PROJECT SPECIAL PROVISIONS**ROADWAY****ASPHALT PAVEMENTS - SUPERPAVE:**

Revise the *2006 Standard Specifications* as follows:

FIGURE 1: Safety Edge Detail

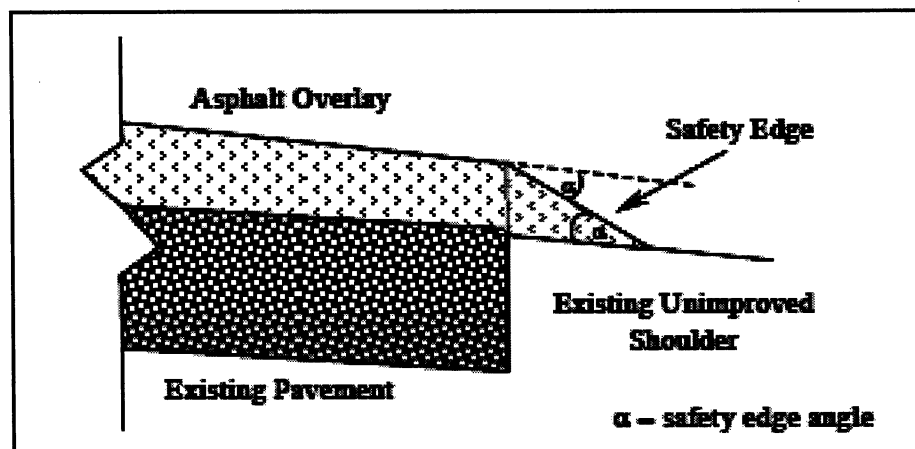
Attach a device, mounted on screed of paving equipment, capable of constructing a shoulder wedge with an angle of not more than 30 degrees along the outside edge of the roadway, measured from the horizontal plane in place after final compaction on the final surface course. Use an approved mechanical device that will form the asphalt mixture to produce a wedge with uniform texture, shape and density while automatically adjusting to varying heights.

See **Figure 1: Safety Edge Detail** for application of safety edge where edge of pavement is not restrained by curbing, curb and gutter, etc.
